TO: Mayor Khalid Kamau, City of South Fulton
ATTN TO: Reginald McClendon, Community Development Managing Director
FROM: Mike Alexander, COO, Atlanta Regional Commission
RE: Development of Regional Impact (DRI) Review

Name of Proposal: MAPCO Industrial Site DRI 4313

Description: A DRI review of a proposal to construct an industrial park with approximately 1.9 million SF of industrial warehouse space on a 191-acre currently forested site east of Old Senoia Road and west of Fayetteville Road in the City of South Fulton in Fulton County.

Z1.0

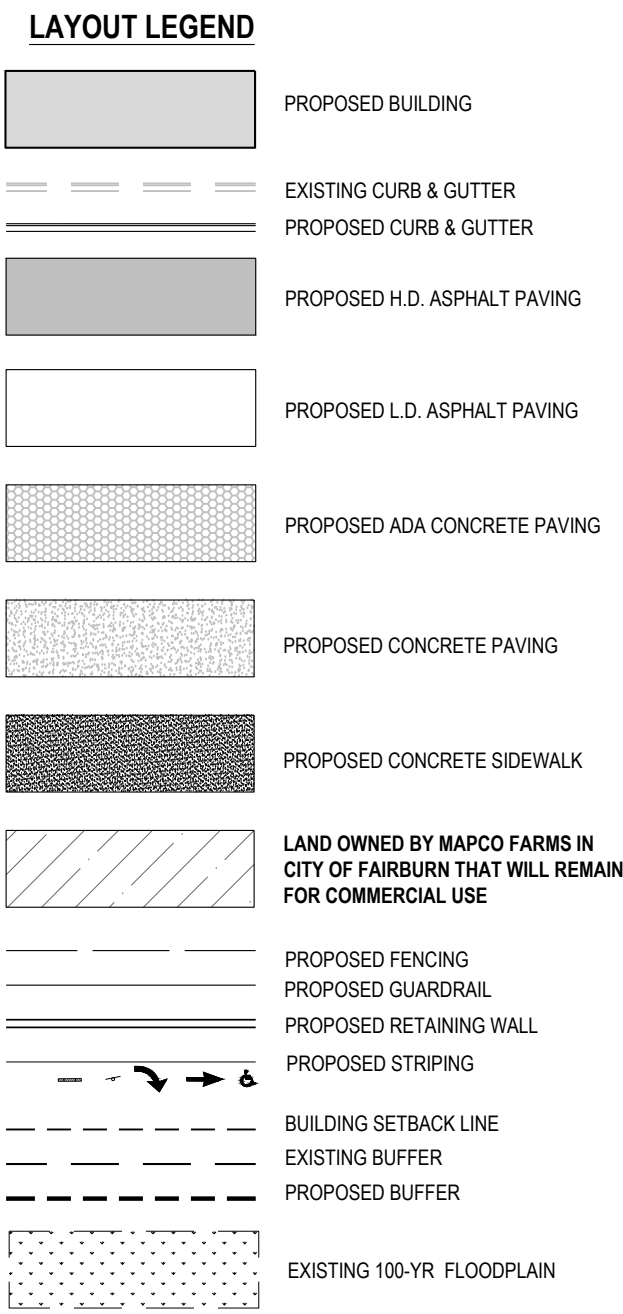
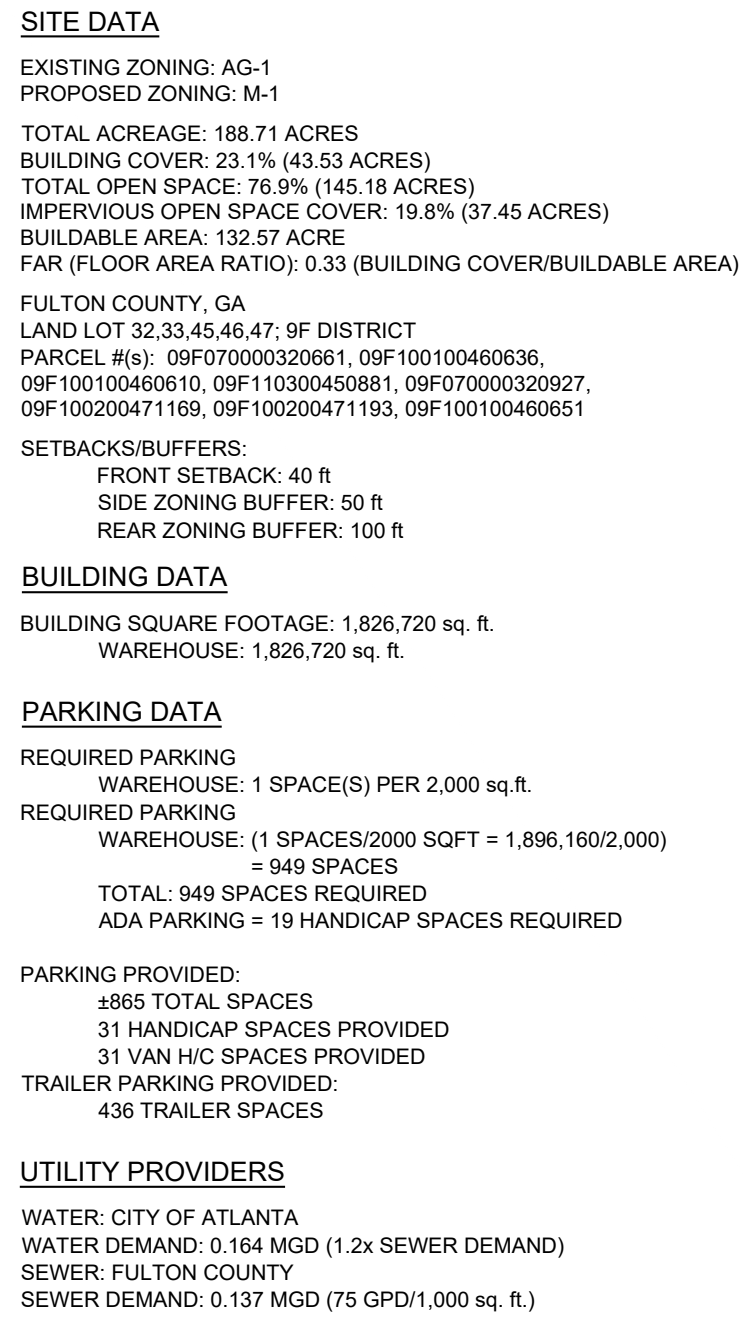
A portion of building 200 and its parking lot are shown sited over an existing stream which may require a stream buffer variance.

The City of South Fulton Stream Buffer Ordinance requires a 75-foot undisturbed buffer with an additional 25-foot impervious setback. The submitted plans show parking, roads and a corner of the proposed Building 200 extending into the buffers and directly over the creek which will require variances from the City.

The USGS coverage for the project area shows no blue-line streams on the property. The project site plan shows an unnamed perennial blue line tributary to Whitewater Creek running roughly north-south on the eastern side of the project property. The corrected site plan shows the 25-foot State Sediment and Erosion Control buffer as well as a 75-foot undisturbed buffer and an additional 25-foot impervious surface setback. The submitted plans show parking, roads and a corner of the proposed Building 200 extending into the buffers and directly over the creek. Any intrusions into the buffers will require variances from the City.

The submitted site plan shows 100-year floodplain in, but not around, two existing ponds on the property, identified as "apparent existing ponds". They are not near the mapped stream and no floodplain is shown along the stream. The FEMA coverage for the project area shows no floodplains on the project property.

The USGS coverage for the project area shows no blue-line streams on the property. The project site plan shows an unnamed perennial blue line tributary to Whitewater Creek running roughly north-south on the eastern side of the project property. The site plan shows the 25-foot State Sediment and Erosion Control buffer as well as a 50-foot undisturbed buffer and an additional 25-foot impervious surface setback. However, the City of South Fulton Stream Buffer Ordinance requires a 75-foot undisturbed buffer with an additional 25-foot impervious setback. In addition, the submitted plans show parking, roads and a corner of the proposed Building 200 extending into the buffers and directly over the creek. The correct City buffers need to be shown, and any intrusions into the buffers will require variances from the City.

The submitted site plan shows 100-year floodplain in, but not around, two existing ponds on the property, identified as “apparent existing ponds”. They are not near the mapped stream and no floodplain is shown along the stream. The FEMA coverage for the project area shows no floodplains on the project property.

Development is an industrial site which does not generally support transit ridership. The proposed site plan adds sidewalks along SR 92, but other sidewalk gaps would need to be addressed for site to be fully walkable to transit stops.

There are some pedestrian improvements on site. Sidewalks allow pedestrians to safely move from the building to parking lots and other site locations. There are no bike improvements.

The site will have a significant amount of truck traffic. This is not able to fully be separated from bike and pedestrian movements.
